I HEREBY CERTIFY THAT THIS STRUCTURE
WAS BUILT ACCORDING TO PLANS EXCEPT
AS NOTED HEREIN
SIGNED: Stanly DATE 4-1-79

PROJECT No. 6.804135
STANLY-MONTGOMERY COUNTY
STATION 58+67.0-L
SHEET 1 OF 2
STATE OF NORTH CAROLINA
STATE HIGHWAY COMMISSION
RALEIGH
GENERAL DRAWING
BRIDGE OVER PEE DEE RIVER
ON NC 24/27
BETWEEN ADERVAARLE AND TROY

GENERAL DRAWING
BRIDGE OVER PEE DEE RIVER
ON NC 24/27
BETWEEN ABERNATHY AND TOLSON

SUBSTRUCTURE
END BENT 2

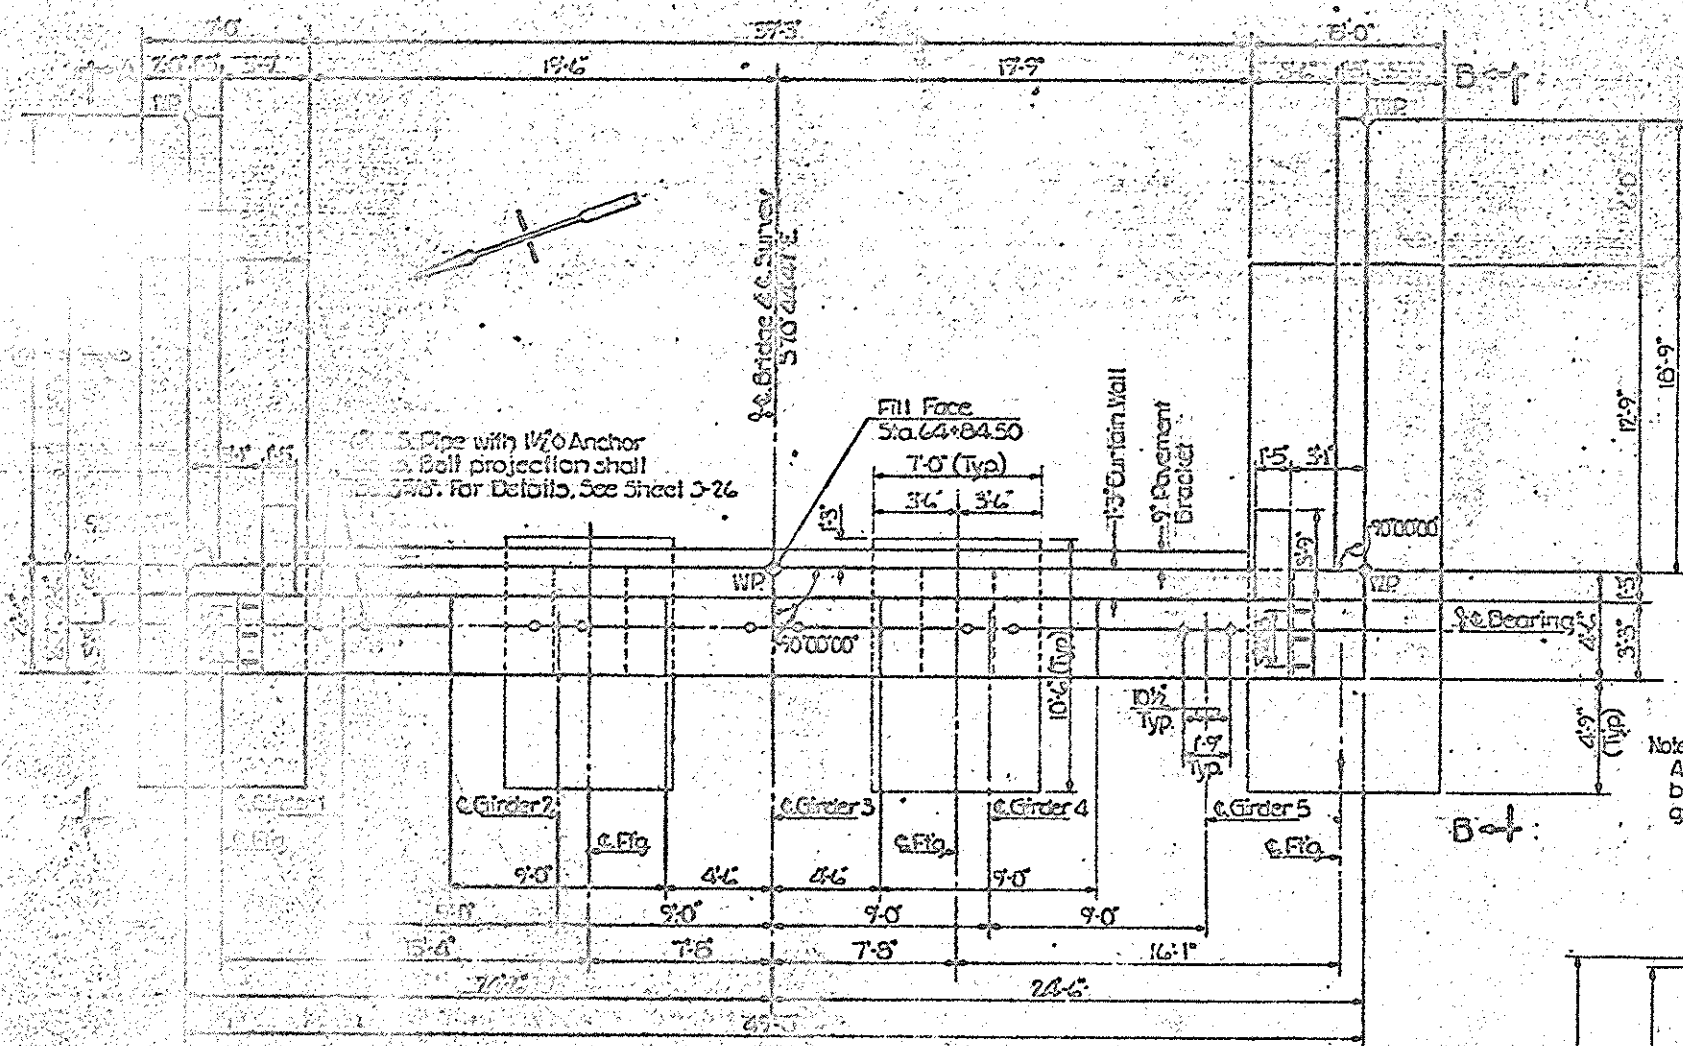
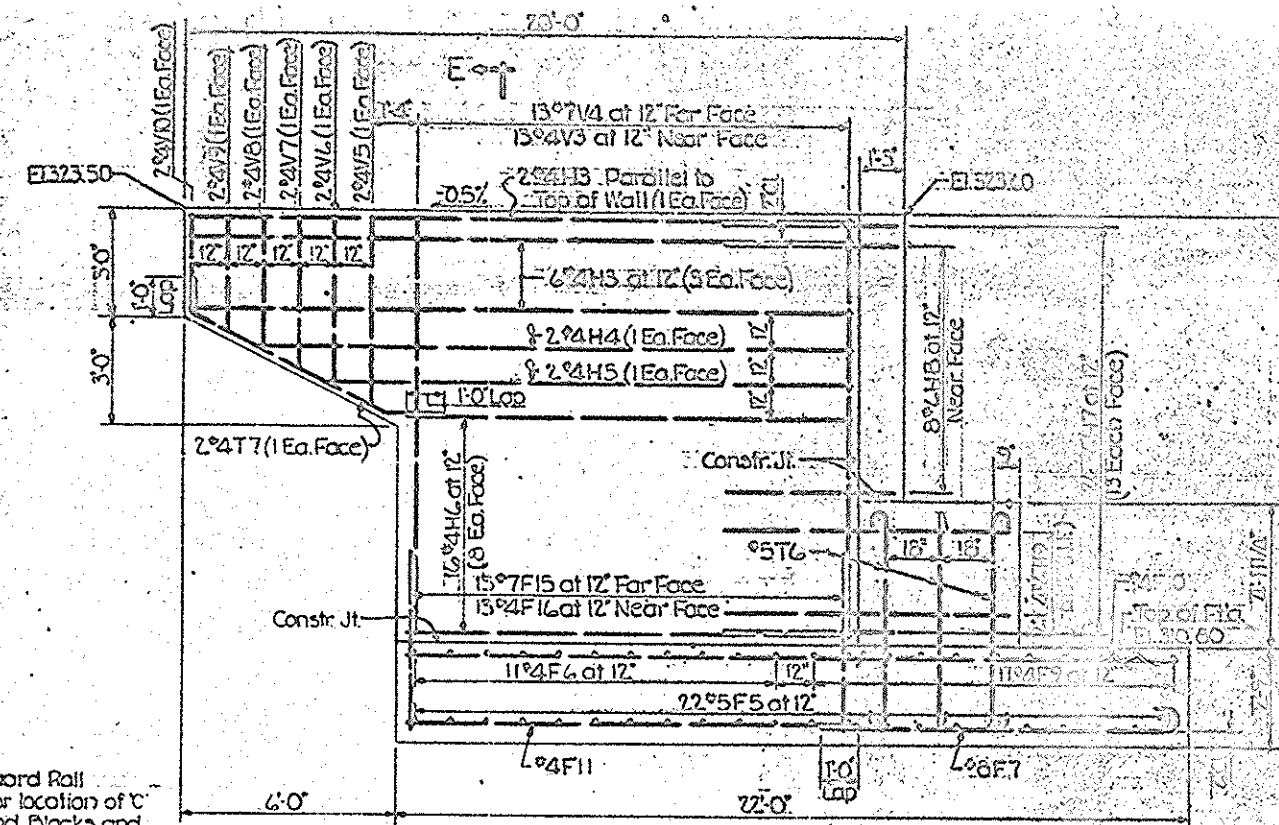
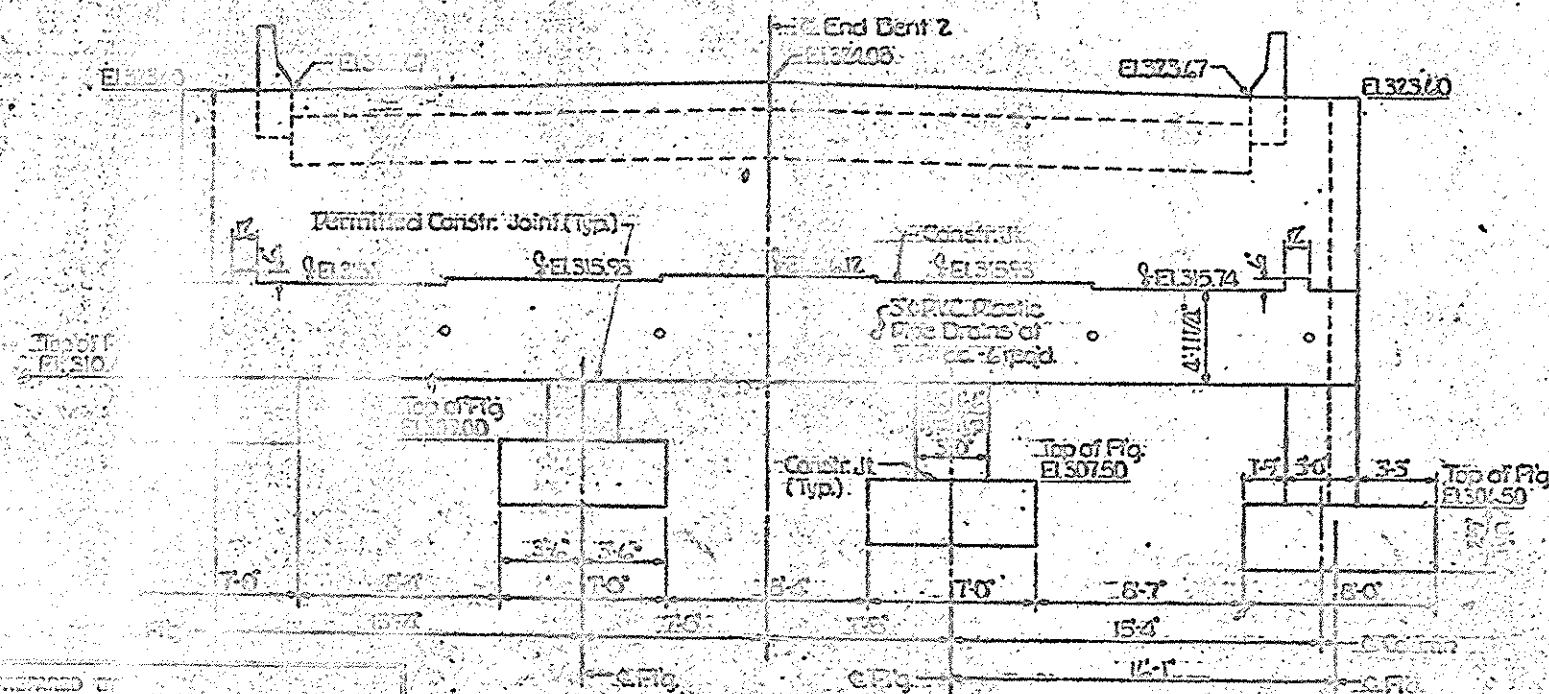
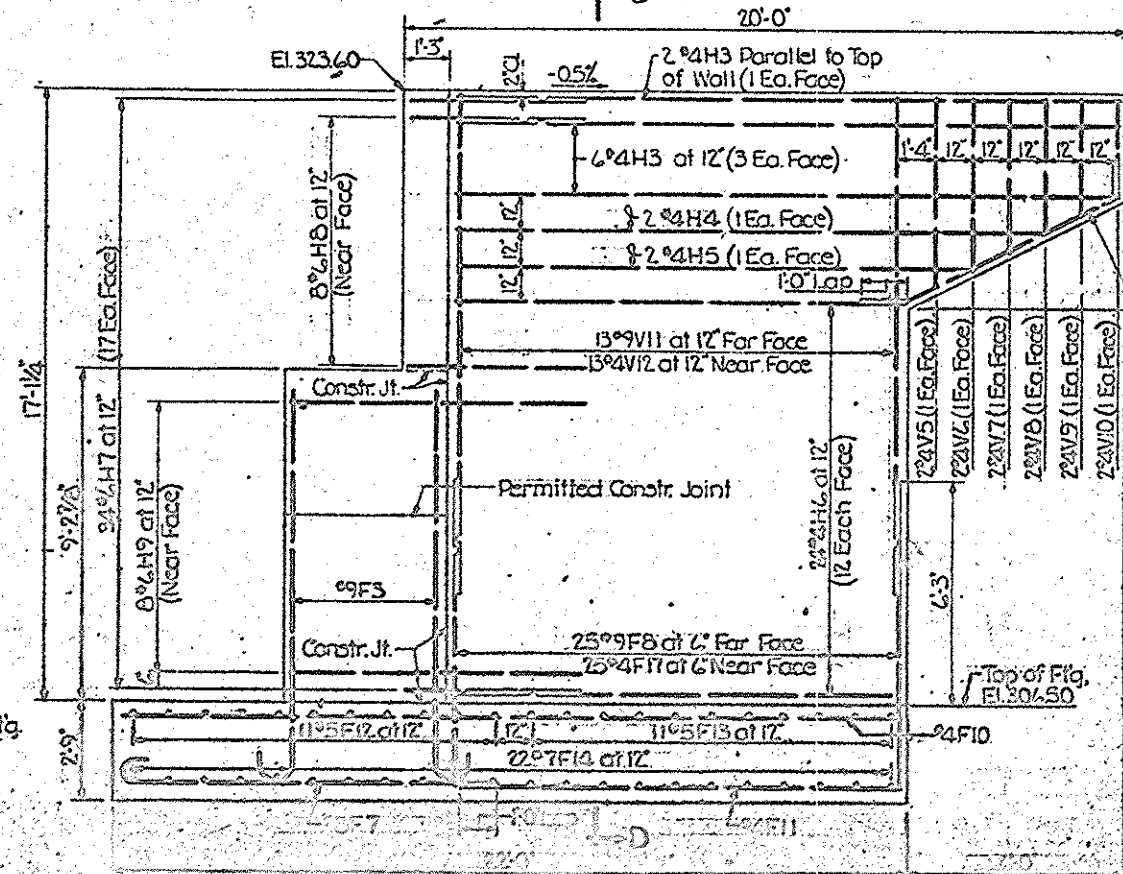
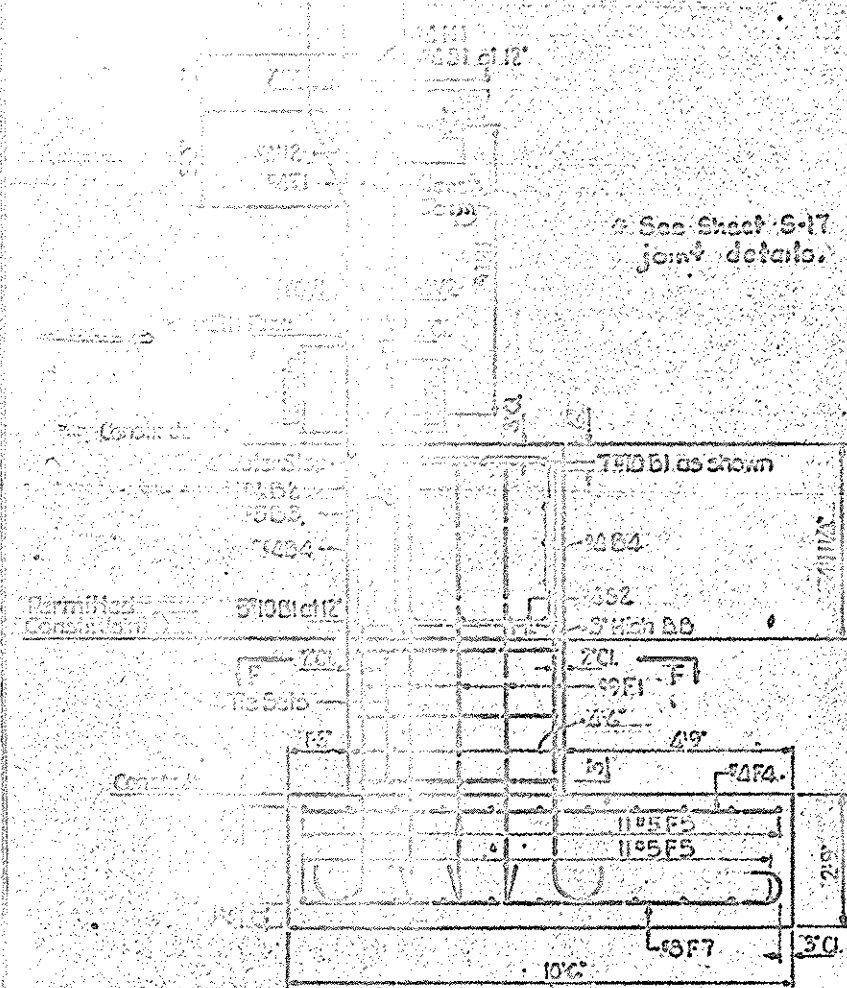
Rebar: Changed Total Reinforcing wt from 169780 to 169407, and Class AA Concrete from 12.6 cy to 39.6 cy. No other changes. 6-9-77 HCS

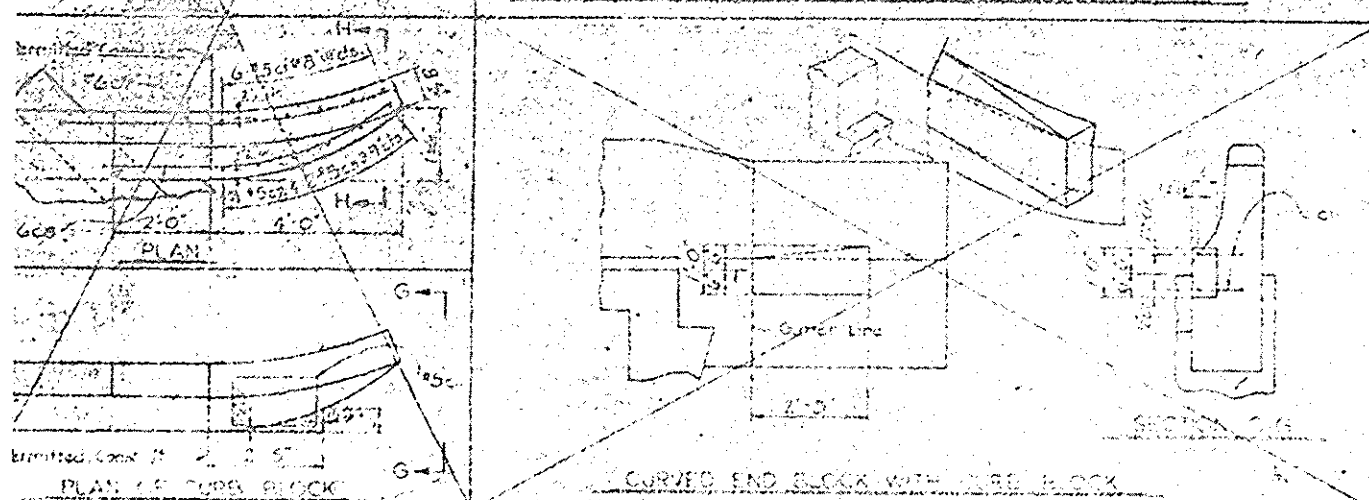
Rev. 1 - Revised to accommodate Exp. Jt. Seal as submitted by the contractor by J.C.C. & by A.R.S.
